DELEGATED REPORT**TO:** SENIOR PLANNER**FROM:** Technical Officer (Subdivisions)**FILE:** OPW/18/0007**DATE:** 19 June 2018

APPLICATION		PREMISES	
FILE NO:	OPW/18/0007	ADDRESS:	Emerald Falls Road, Mareeba
APPLICANT:	Kanjini Co-Op Ltd	RPD:	Lot 67 RP896904 (now Lot 67 on SP177749)
LODGED BY:	Kanjini Co-Op Ltd	AREA:	936.18 hectares
DATE LODGED:	12 June 2018	OWNER:	Kanjini Co-Op Ltd
TYPE OF APPROVAL:	Development Permit		
PROPOSED DEVELOPMENT:	Operational Works for Reconfiguring a Lot - Subdivision (1 into 4 lots plus balance area) approval DA/13/0085		
PLANNING SCHEME:	Mareeba Shire Council Planning Scheme 2016		
ZONE:	Rural Zone		
LEVEL OF ASSESSMENT:	Code Assessment

The development application seeks a Development Permit for Operational Works for Reconfiguring a Lot - Subdivision (1 into 4 lots plus balance area) approval DA/13/0085.

Typical Cross Section Plan

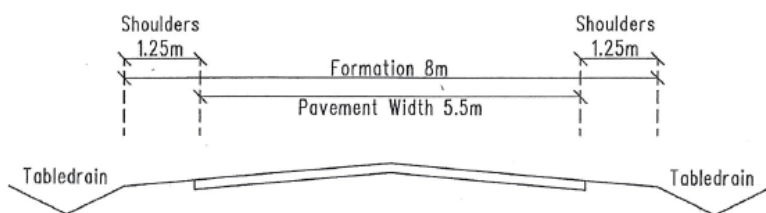
The upgrading of the existing road surface must not affect the longitudinal section of Emerald Falls Road.

If unsure consult FNQROC and Council's delegated officer
